**Victorian Transmission System
Access Arrangement 2018 – 2022**

**Review of Forecast Capex
for
Selected Projects**

**Report
to
Australian Energy Regulator
by
Roland Sleeman**

27 April 2017

Figure 1: Typical Minimum Slabbing Requirement

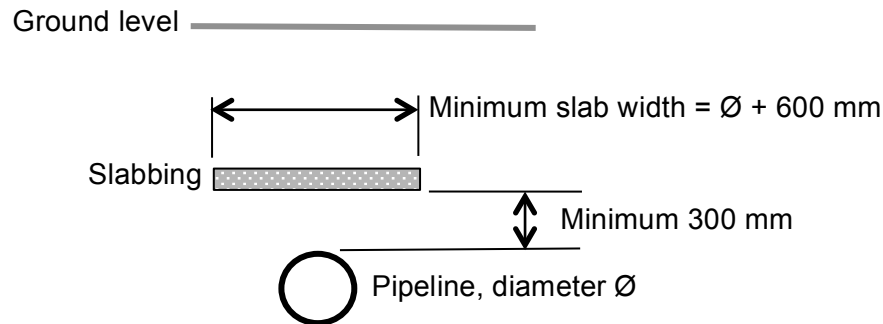
- 2.6 The costs of slabbing, as presented in Table 2, are as estimated by APA VTS. I note the following:
- i) The typical minimum requirement for installation of slabbing is depicted in Figure 1.

- ii) APA VTS has advised⁶ that it installs slabbing with a width that extends to 600 mm either side of the pipeline to be protected.
 - iii) Provided APA VTS's slabbing cost estimates are based upon field experience using contracted services, and have regard for excavation conditions on either side of the original trench within which the pipeline is laid, then I consider the estimates to be reasonable. I recommend it be confirmed that the cost estimates are based upon field experience.
- 2.7 In all cases set out in Table 1, a reduction of pipeline operating pressures can remove the risk of pipeline rupture and is therefore an alternative to installation of slabbing. However, operating pressure reductions will also lead to a reduction of the capacity of the pipelines in question. Specific observations in relation to each affected pipeline are:

Figure 2: Forecast and Actual Peak Gas Flows at Warragul City Gate

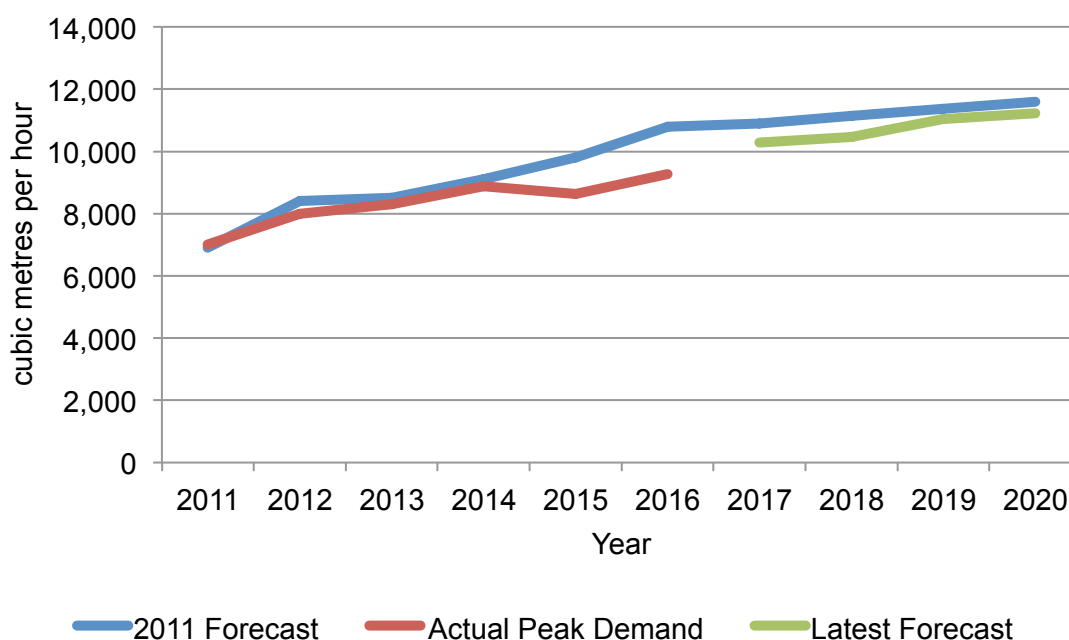
- 4.2 APA VTS did not carry out the looping project and, although actual peak gas demands were marginally below what had been forecast (as shown in Figure 2), a breach of the Warragul City Gate minimum pressure requirement occurred in 2014.

- 4.4 The AEMO forecasts²⁴ continued gas demand growth on the Warragul gas distribution network. This is illustrated²⁵ in Figure 2.

Figure 3: Warragul Tariff D Historic Gas Demand²⁶

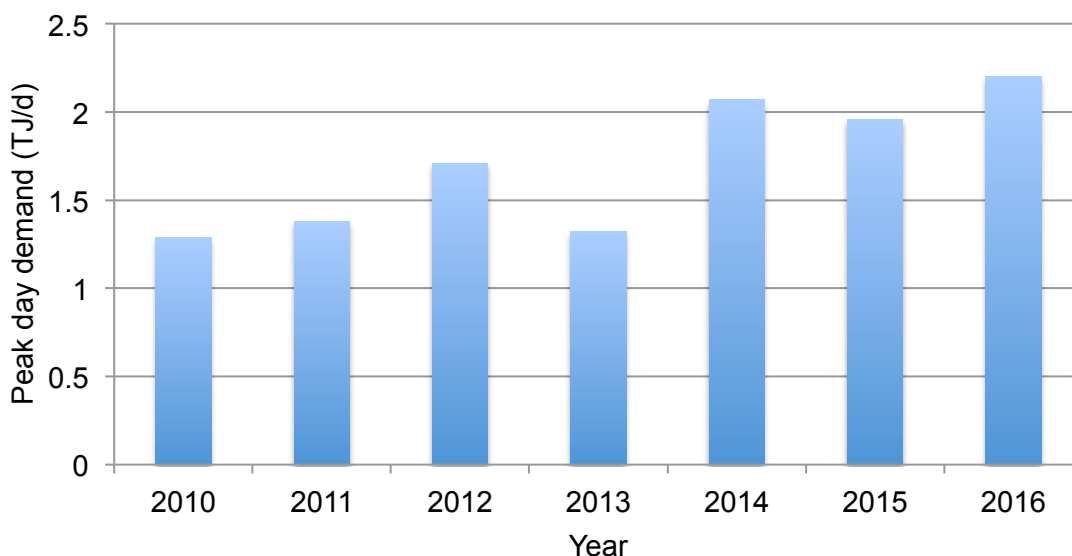
- 4.5 While I am unable to opine on the validity of the forecast demand growth, I am of the view that the peak demand growth that has been experienced represents a permanent, rather than temporary, change. As illustrated in Figure 3, it is clear that the Warragul Tariff D load(s) underwent a step increase in 2014.

Figure 4: Warragul (south) Land Zoning

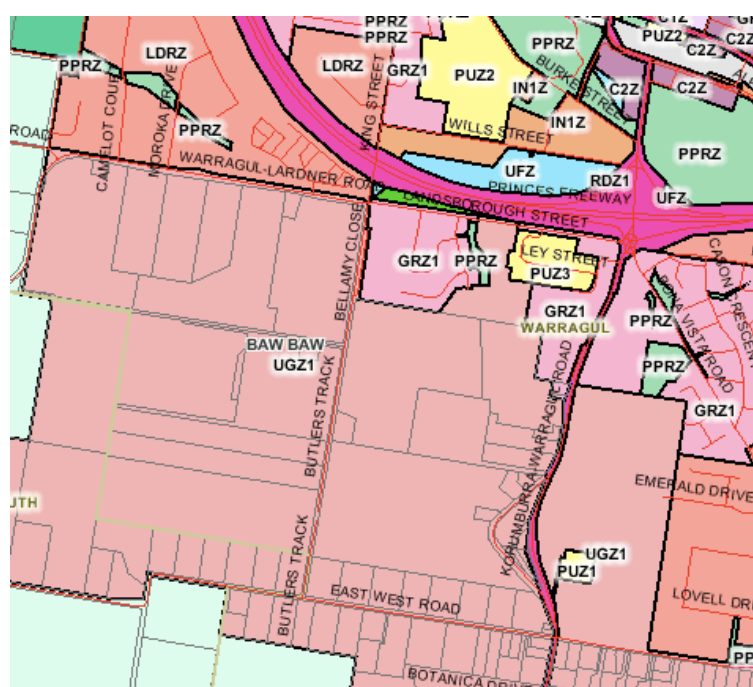
- 4.10 APA VTS has advised²⁷ that the principle driver of the three-fold increase in the estimated cost of the Warragul looping project is changes of land use and urban encroachment, which have resulted in higher land access and pipeline construction costs. I accept this proposition. While there is, as yet, little evidence of new development along the route of the proposed looping pipeline, it is clear that much of the route, along East West Road and Butlers Track, is now within urban growth area ('UGZ1'), as illustrated in Figure 4.

Figure 5: Warragul (northeast) Land Zoning

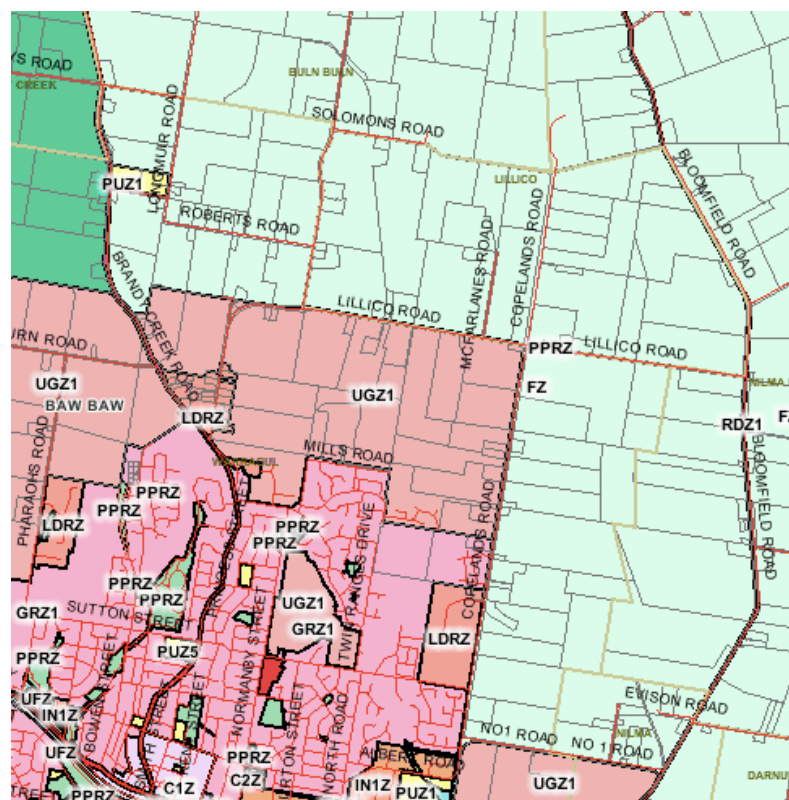
- 4.11 While land zoning and urban encroachment have impacted the cost of APA VTS' proposed Warragul looping project, the same cannot be said for the possible alternative development involving a new source of gas supply to Warragul from the Longford – Melbourne Pipeline (running north of Warragul). As shown in Figure 5, land to the east of Copelands Road (where the alternate pipeline would be located) is zoned for farming ('FZ').

- 4.12 I do not consider APA VTS' \$8.7m estimate of the cost to install a new lateral to Warragul from the Longford-Dandenong pipeline, together with a new city gate station, (paragraph 4.7.ii above), up from \$2.5m in 2012, to be substantiated.
- 4.13 AEMO has identified²⁸ that development of a new lateral to Warragul from the Longford-Dandenong Pipeline may deliver the following benefits not realisable with APA VTS' proposed looping project:
- i) increased security of gas supply, since an additional source of gas supply will be connected; and
 - ii) reduced load on the Lurgi Pipeline, thereby supporting longer term demand growth on that pipeline.

4.15 I recommend that the option of developing a new pipeline lateral (and city gate station) to supply gas to Warragul from the Longford-Dandenong Pipeline be more fully investigated.
